DETAILED ACTION

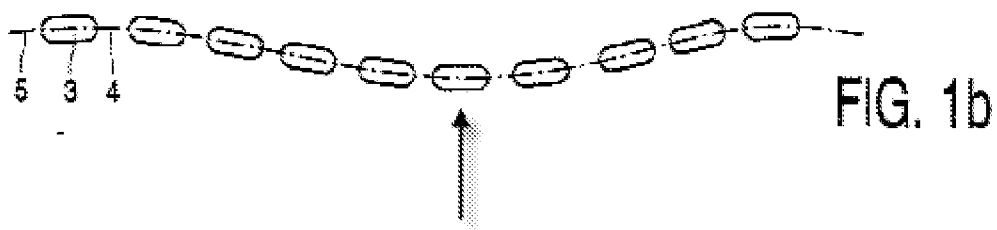
In the above figure from Oostveen, a pregroove pit area is located at a peak value of the wobble, indicated at the arrow. It is clearly the case though that it is only a minority of pregroove pit areas that match this criterion.
